ADDENDUM NO. 1

April 12, 2021

HANOVER CENTRAL HIGH SCHOOL ADDITIONS AND RENOVATIONS Cedar Lake, IN 46303

C P-113

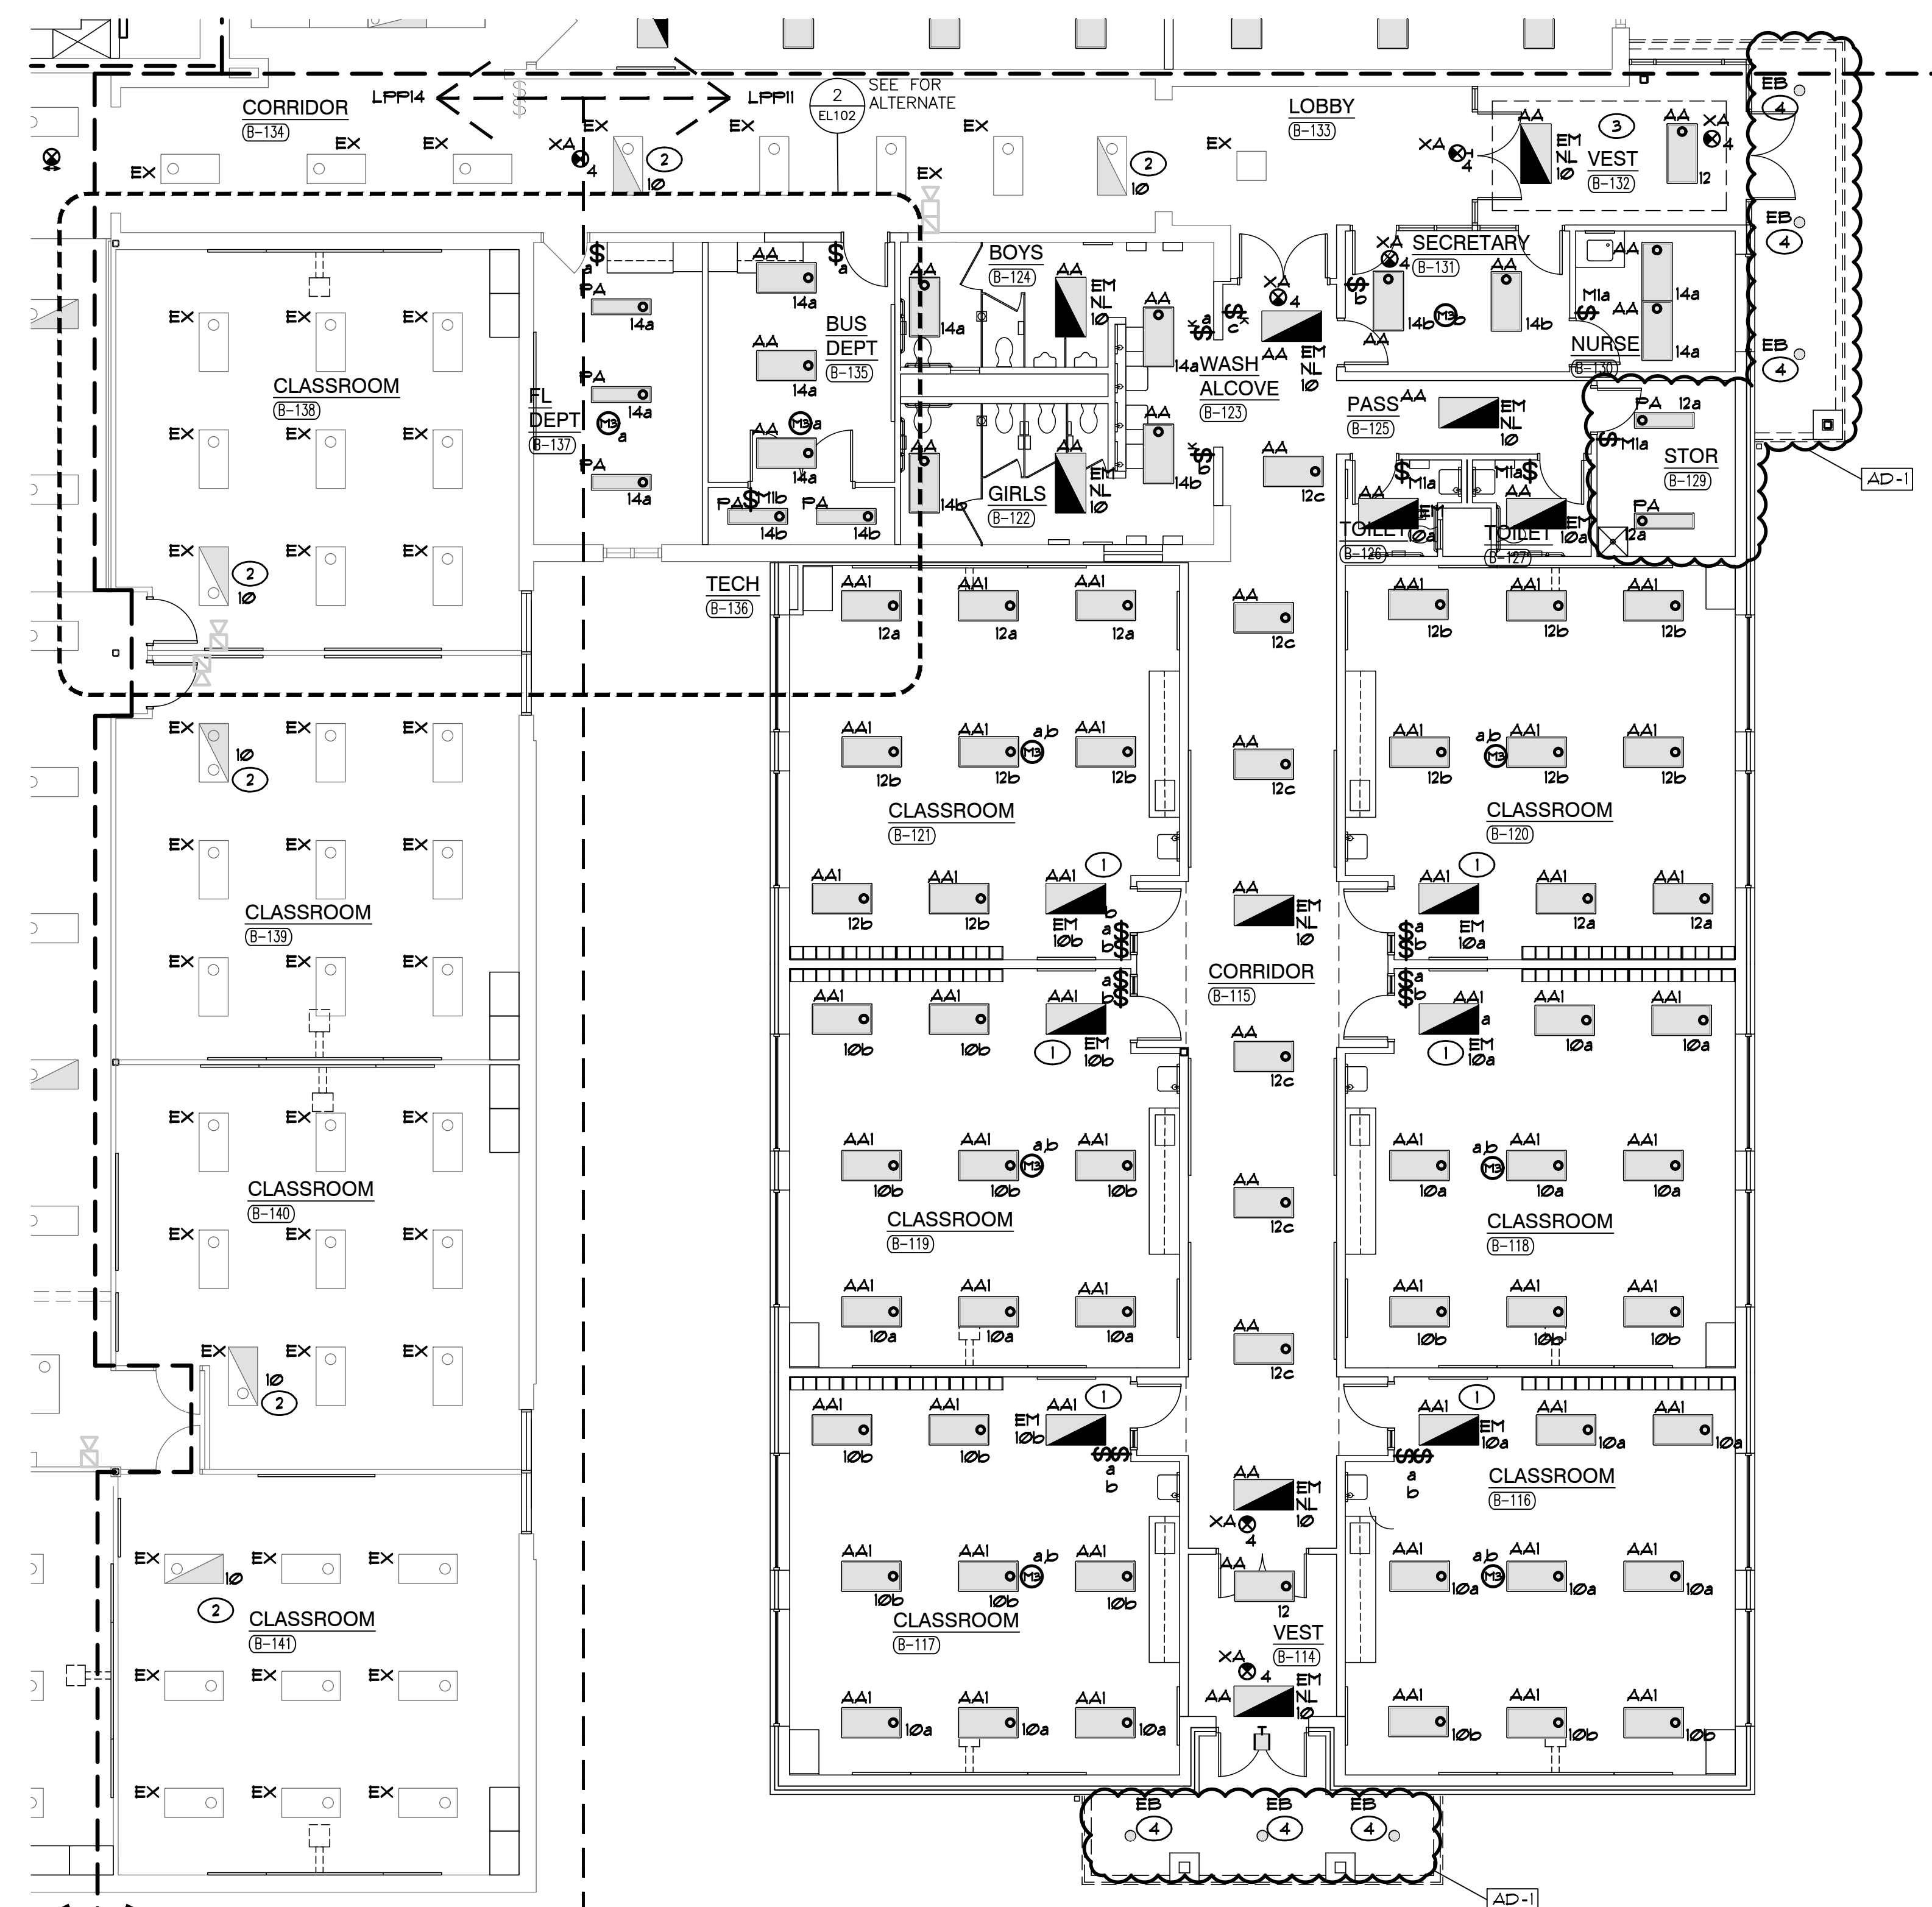
- A. Refer to revised full-size drawing, included in this Addendum, for the following revisions.
 1. Added sheet note 6.
 2. Added sheet notes clarifying the cutting and patching of existing walls.

© GIBRALTAR DESIGN	SHEET
E	EL105

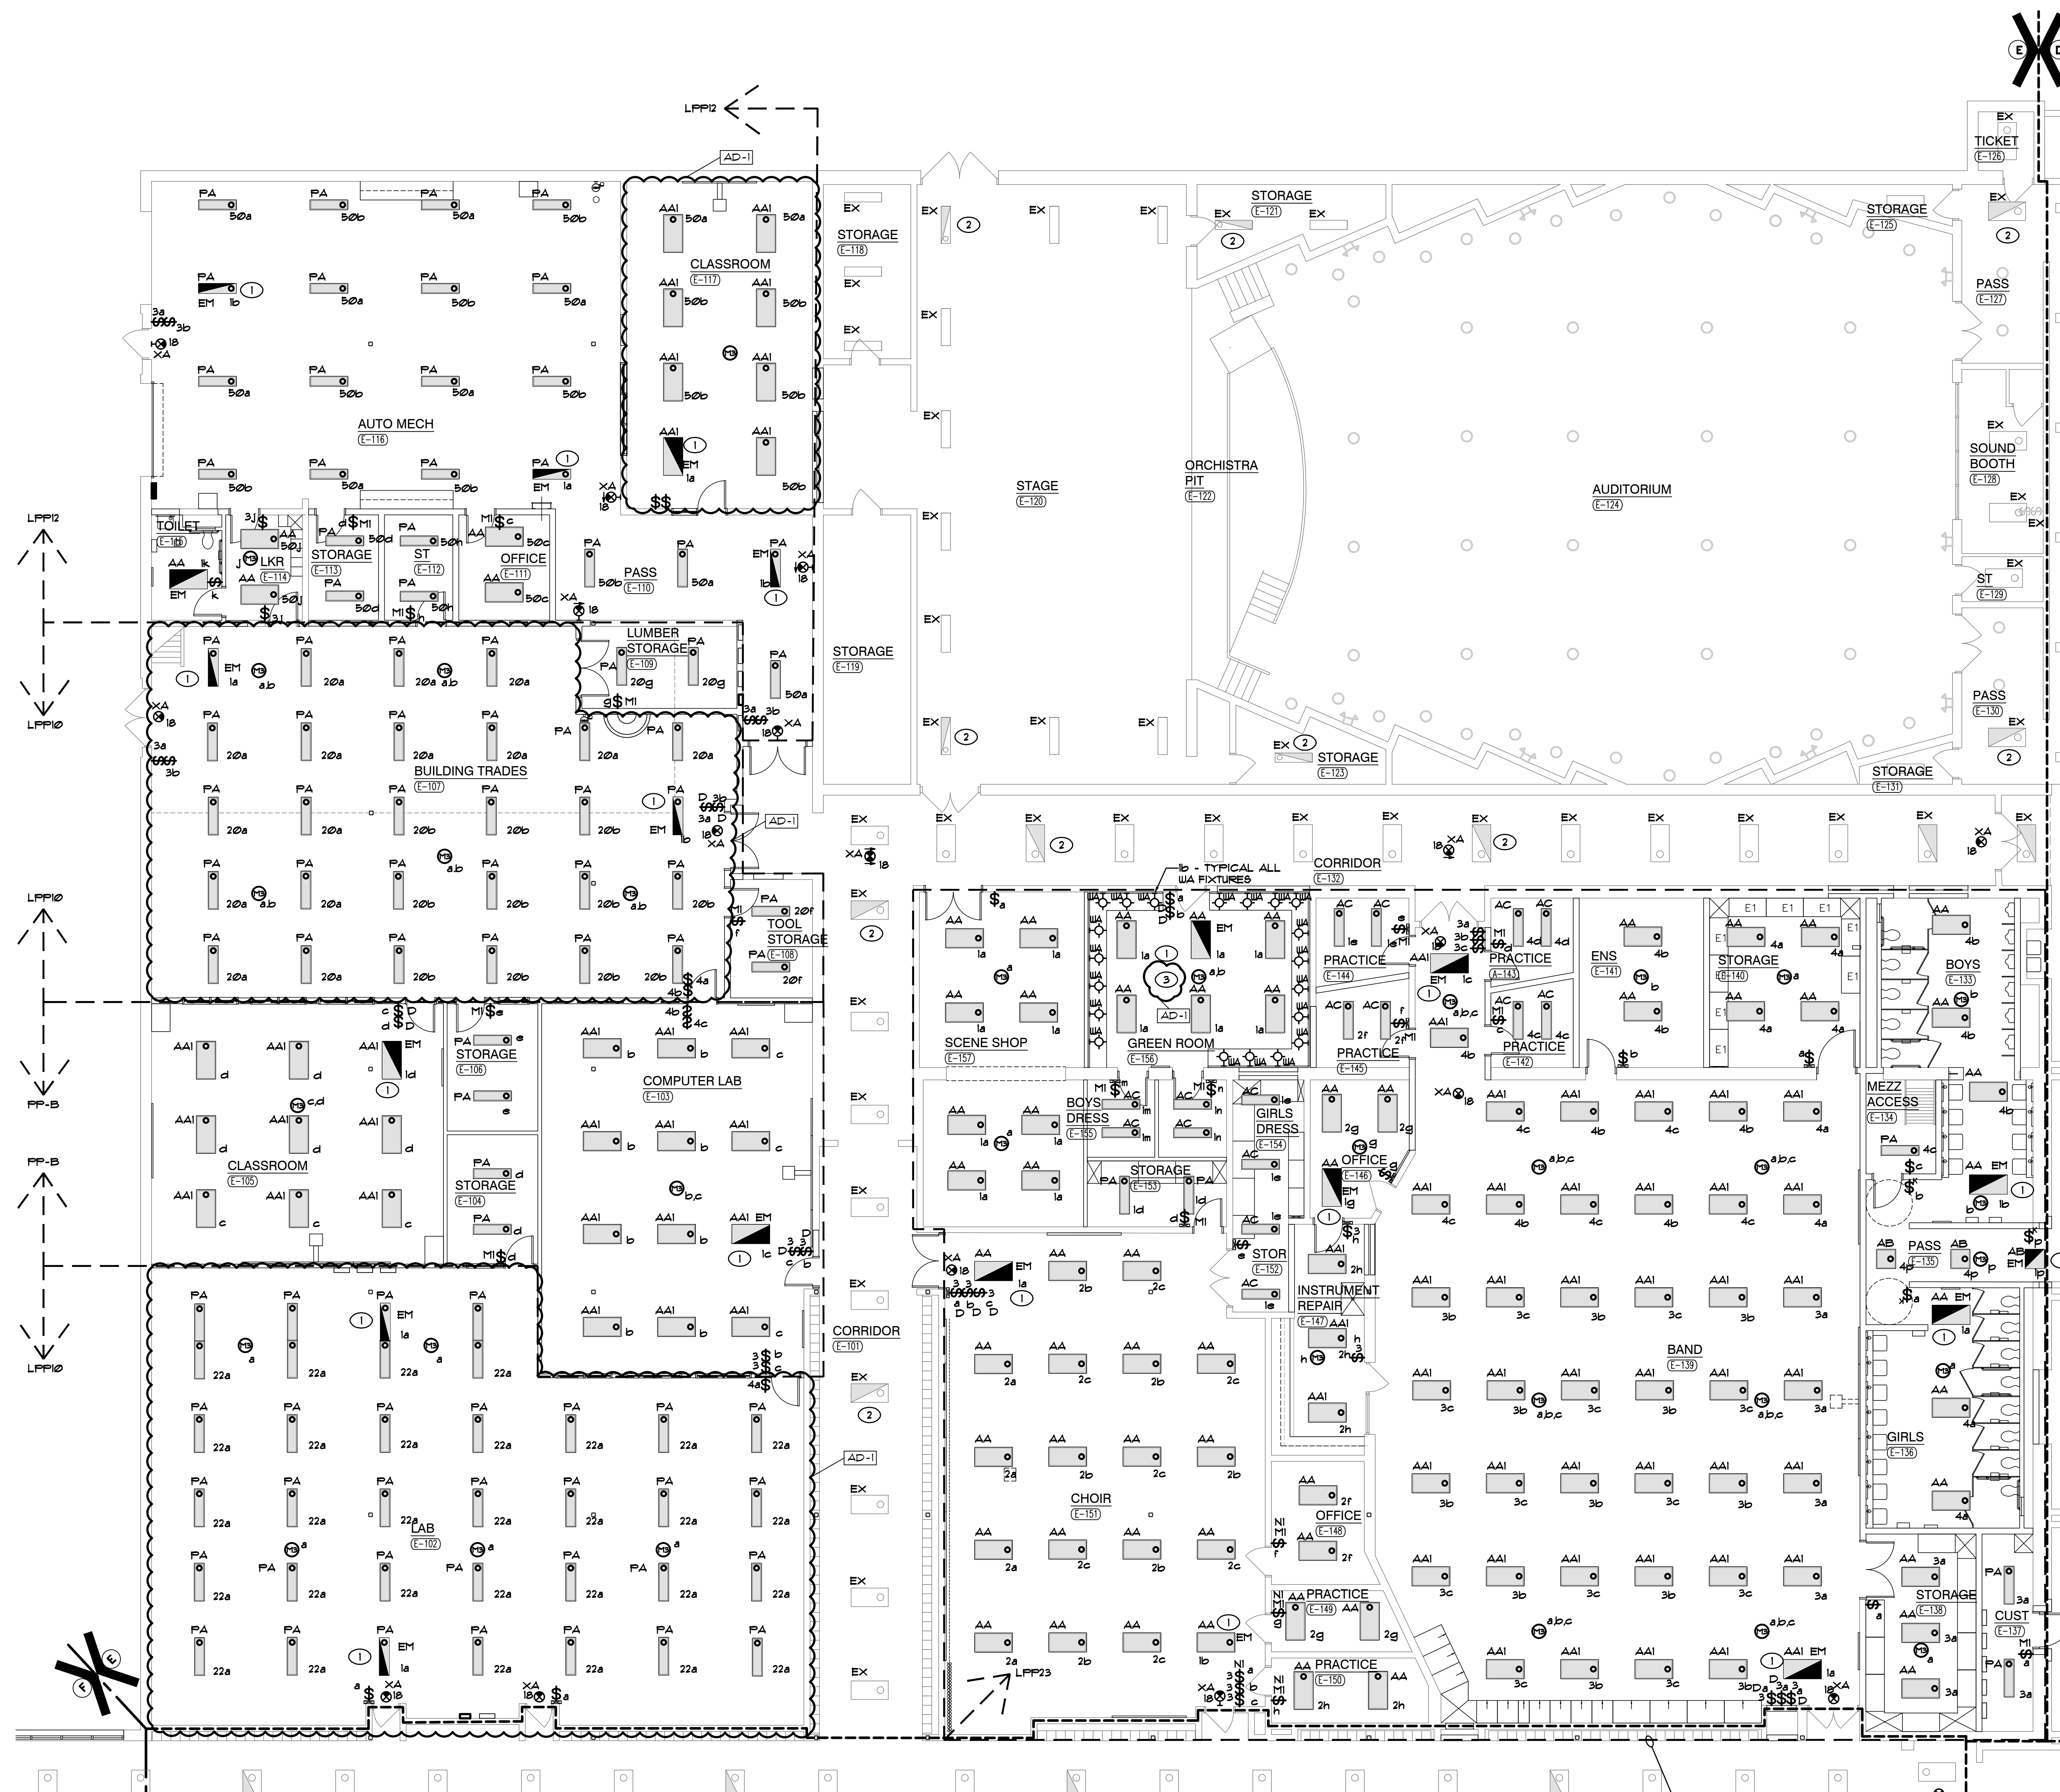
- A. Refer to revised full-size drawing, included in this Addendum, for the following revisions.
 - 1. Classroom E-117: Revise lighting from pendant PA fixtures to recessed AA1.
 - 2. Building Trades E-107: Revise lighting from recessed 2x4 to pendant PA fixtures
 - 3. Lab E-102: Revise lighting from recessed 2x4 to pendant PA fixtures.
 - 4. Green Room E-156: Add note #3 indicating fixtures WA to be mounted horizontally across all mirrors, no vertical sections of light are required.

F	EP106
---	-------

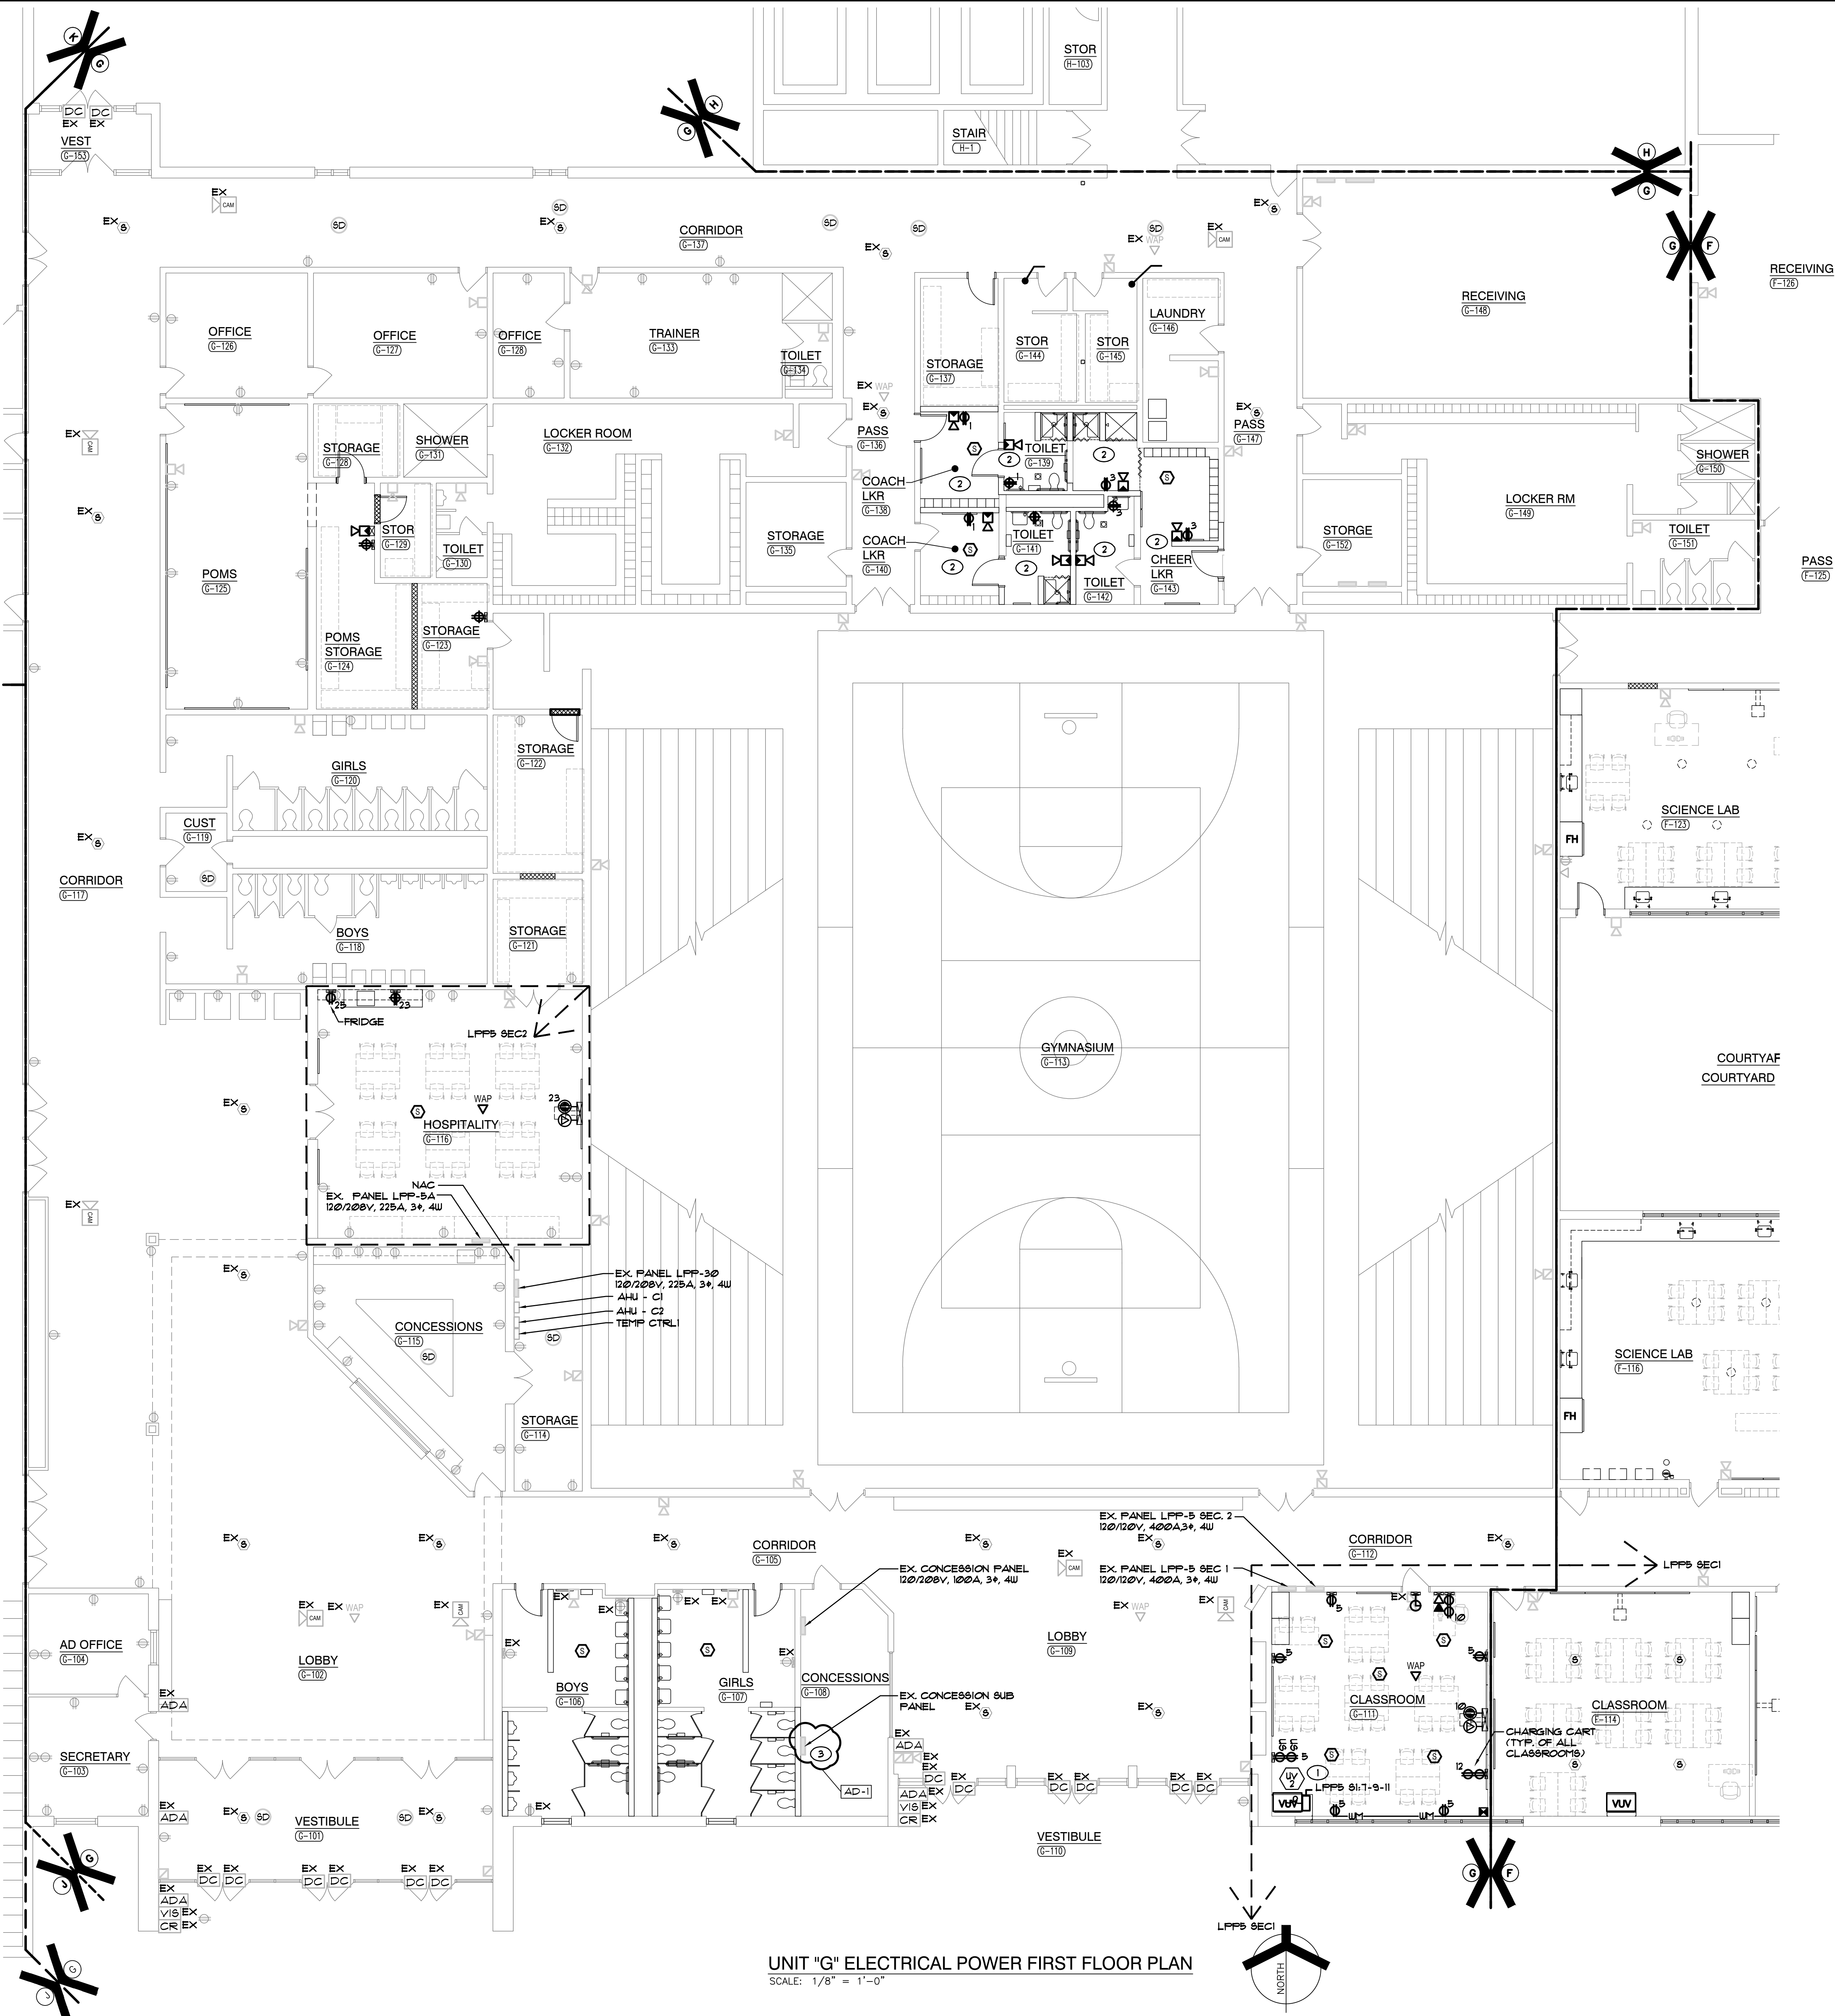
- A. Refer to revised full-size drawing, included in this Addendum, for the following revisions.
 - 1. Add note #2 indicating select receptacles to be installed in casework in rooms Science Lab F-123, Science Lab F-116, Chemistry Lab F-139, Chemistry Lab F-137, and Science Lab F-136
